ADDENDUM #08

INVITATION TO BID #01

ACES at CHASE

STATE PROJECT NO. 244-0044 MAG

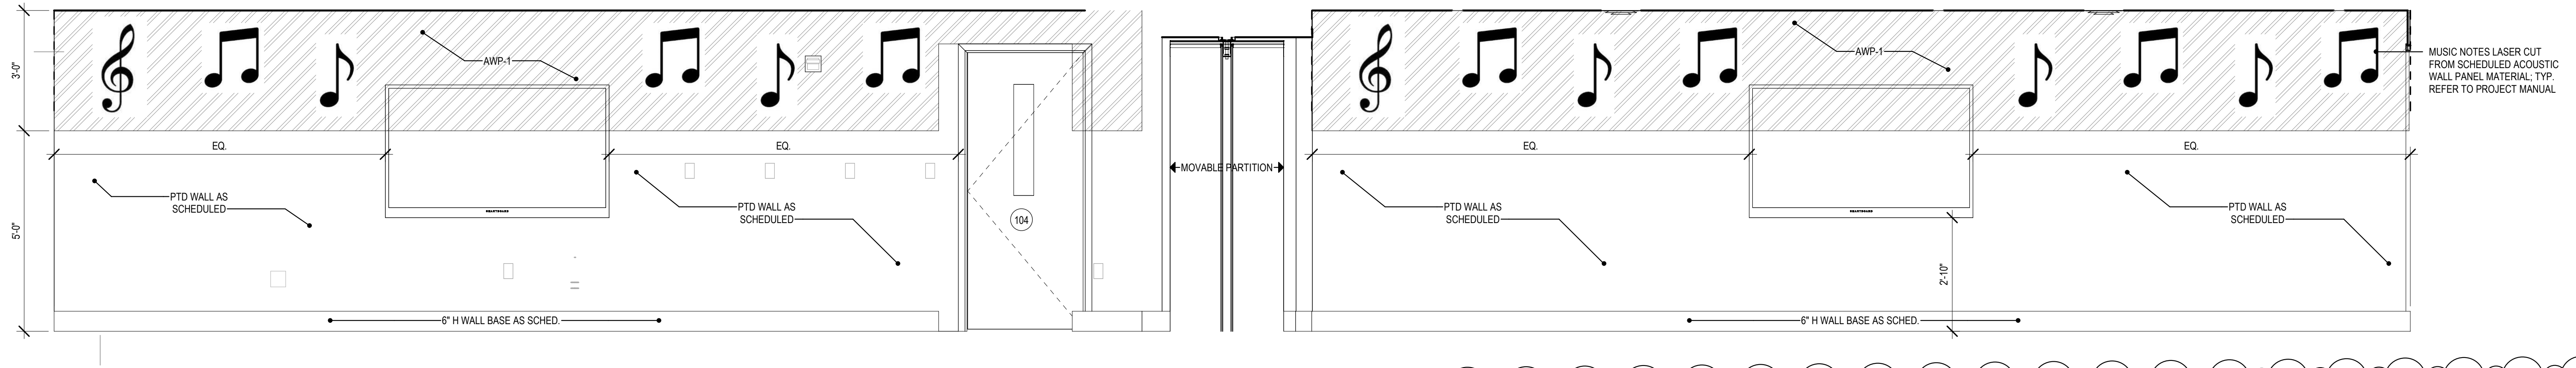
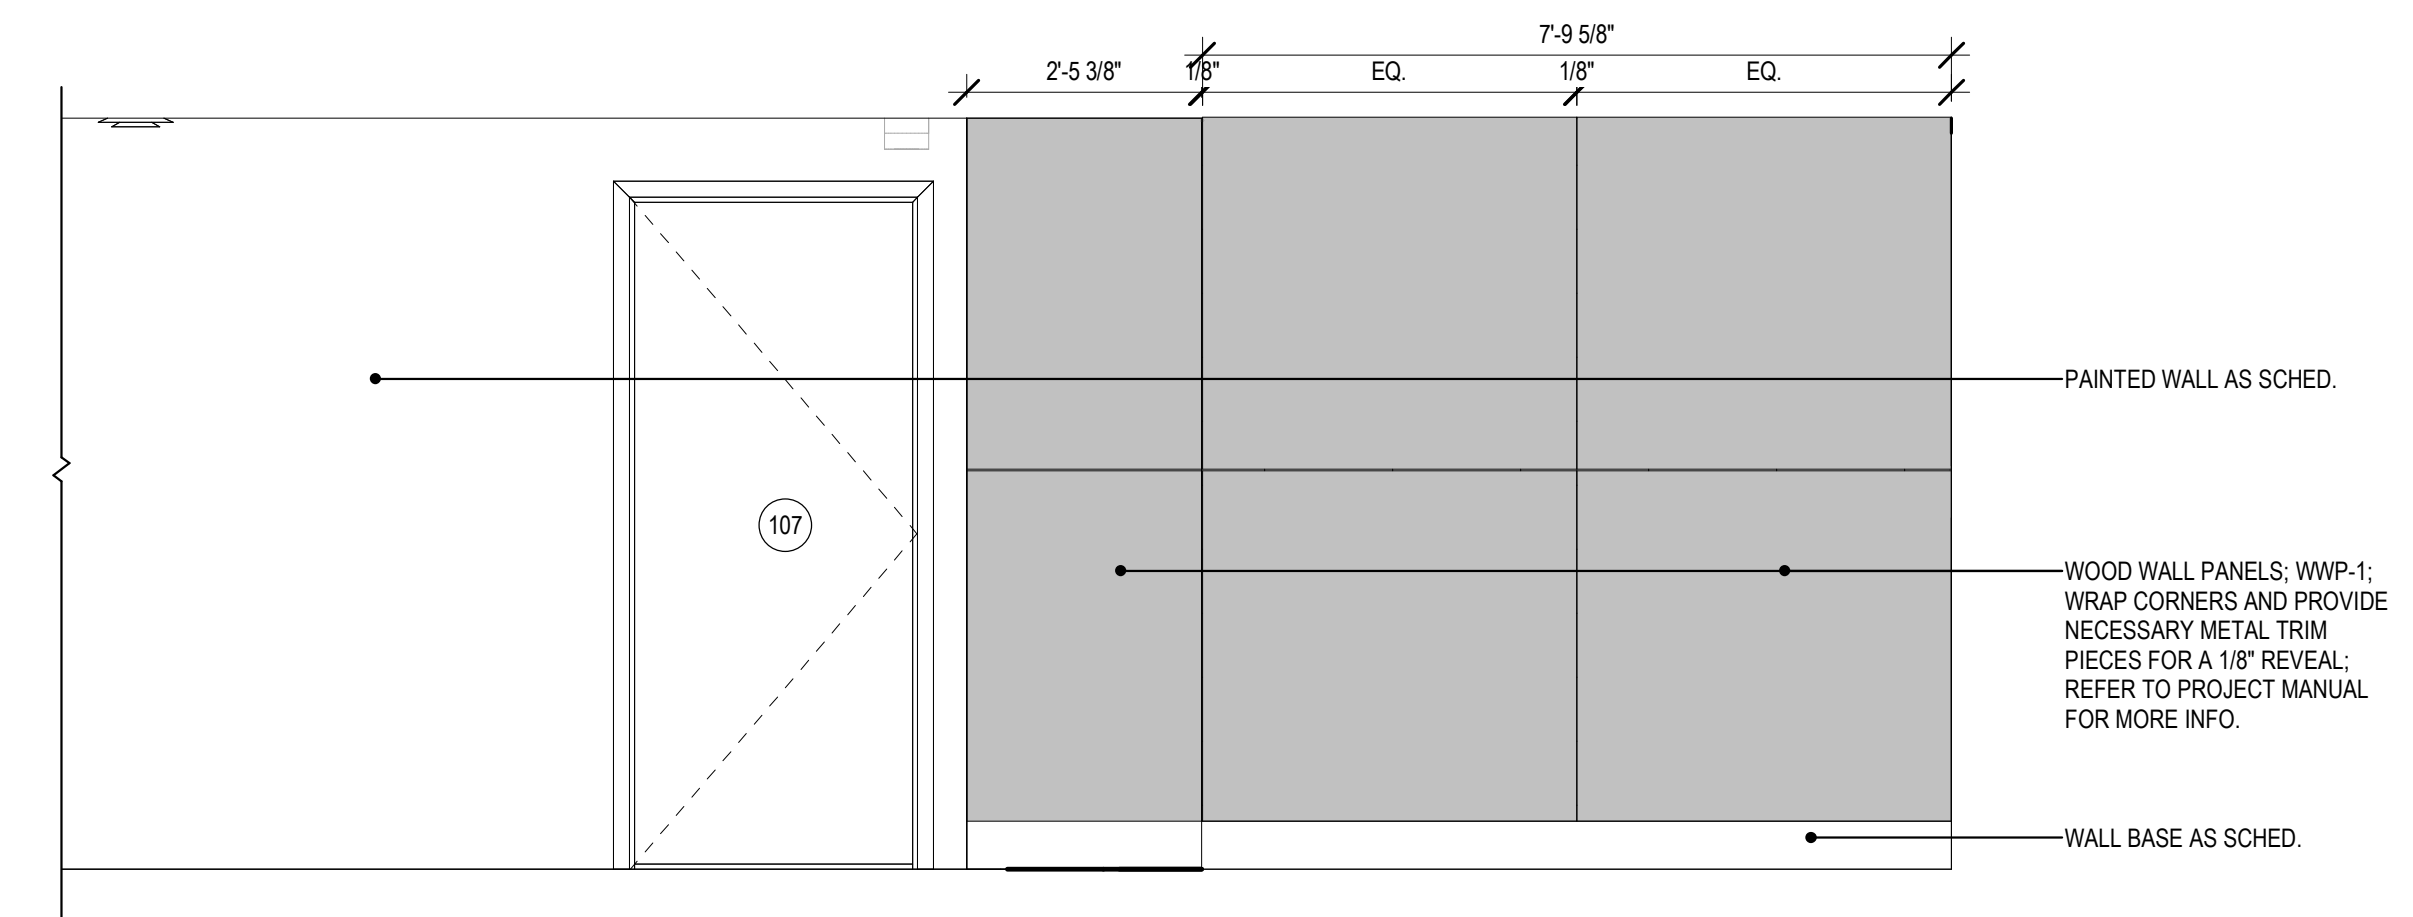
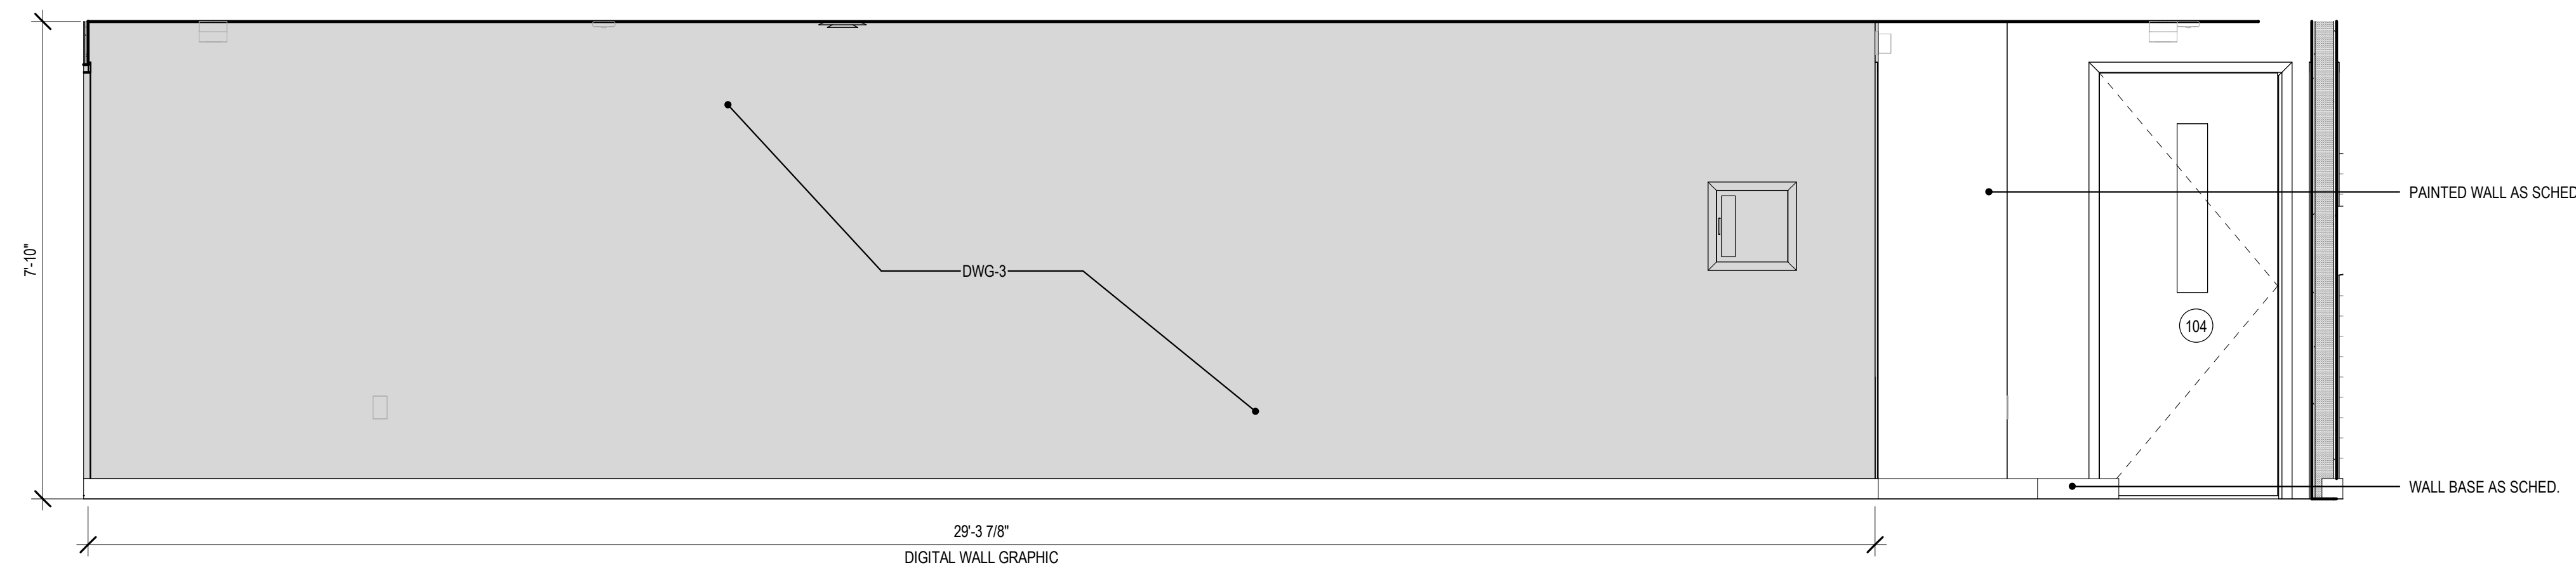
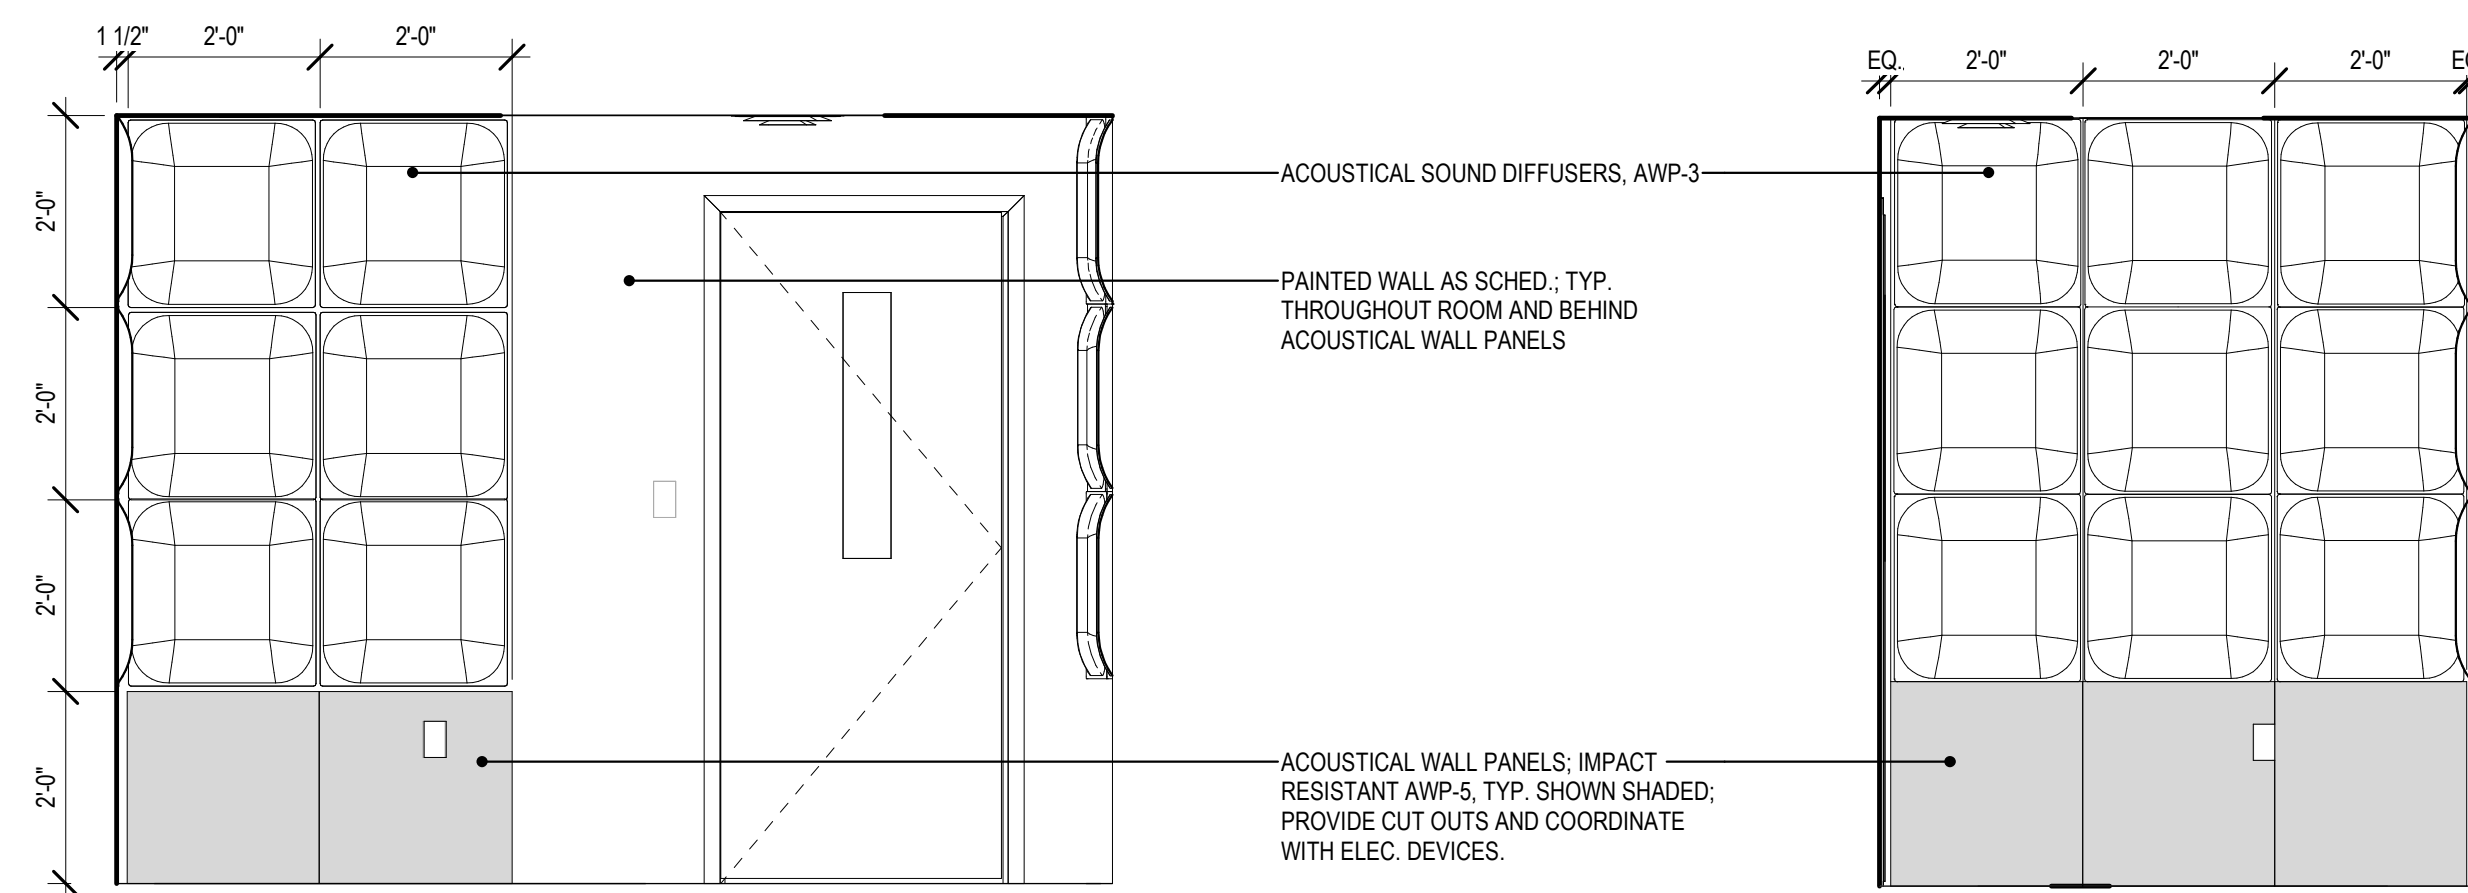
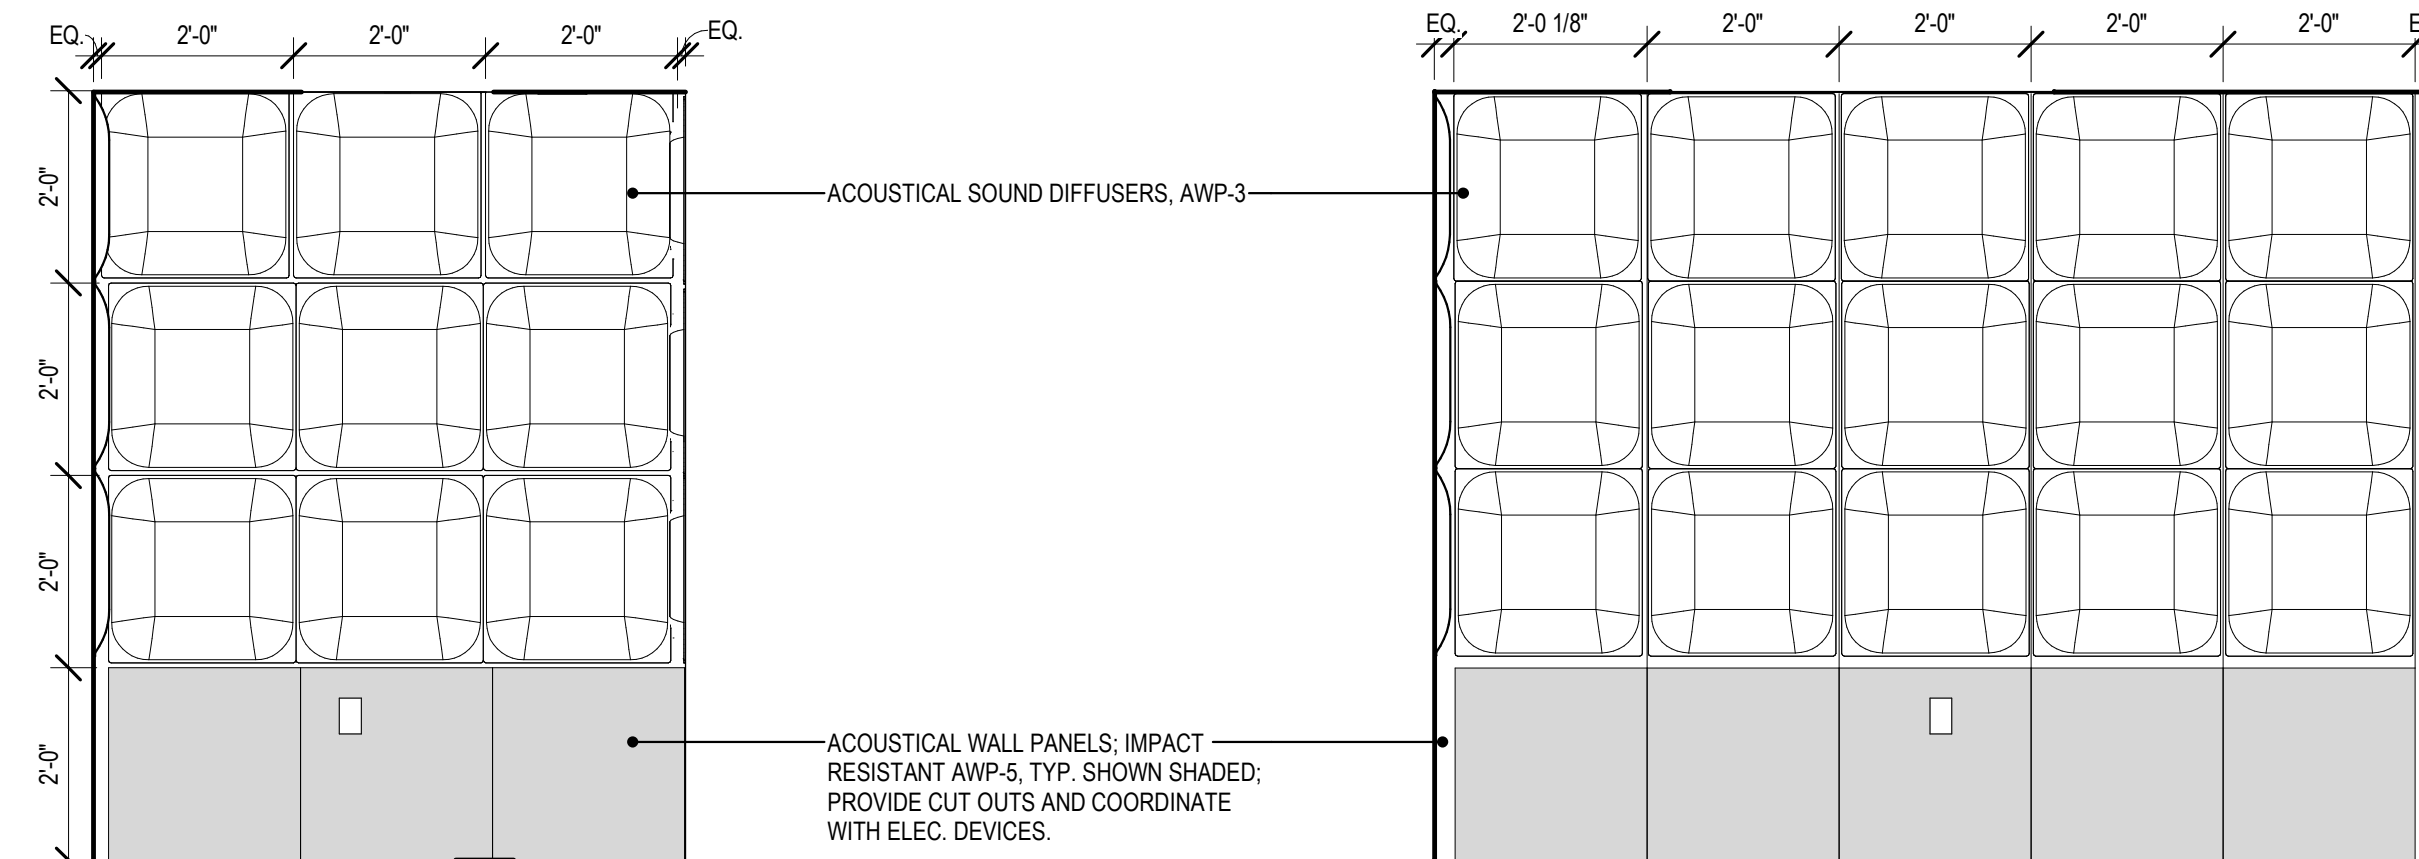
- .1. Yes. Refer to Bulletin #4 for revised Drawing A730-4.
 - .2. There are varying substrates (existing & new masonry & new gypsum board). Refer to floor plans for partition types.
 - .3. Refer to Bulletin #4 for revised Drawings A110-4 & A500-4.
 - .4. There is a wall base as scheduled. Refer to Bulletin #4 for revised Drawing A730-4.
 - .5. Refer to Bulletin #4 for revised drawings as noted above indicating WWP-1 to wrap around column.
- 1.a.ii.
- .1. Refer to Bulletin #4 for revised drawings as noted above indicating WWP-1 to wrap around column.
 - .2. Refer to Bulletin #4 for revised drawings as noted above indicating WWP-1.
 - .3. Yes.
 - .4. Refer to Bulletin #4 for revised Drawing A730-4.
 - .5. There is a wall base as scheduled. Refer to Bulletin #4 for revised Drawing A730-4.
- S/P+A-KD
